# Service Bulletin

Bulletin No: T-4Date: Oct. 24, 1975

Service AMRSubject: T500 SWING ARM PIVOT SHAFT

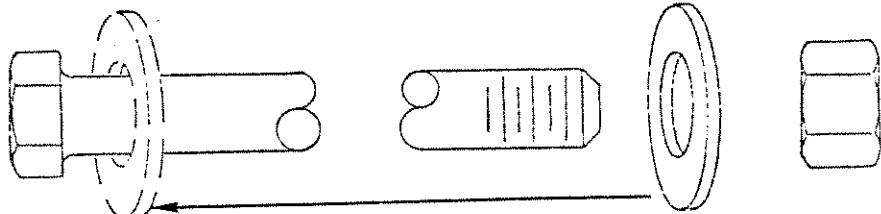
The shoulder radius of the T500 swing arm pivot shaft has been increased from 0.5mm to 1.0mm.

To accept the new type pivot shaft, the frame boss chamfer has also been increased 0.5mm.

**NOTE:** Should it be necessary to install a new type pivot shaft through an old type frame boss, simply move the washer from the nut side to the head side of the swing arm pivot shaft. The washer will conform to the shoulder radius of the pivot shaft.
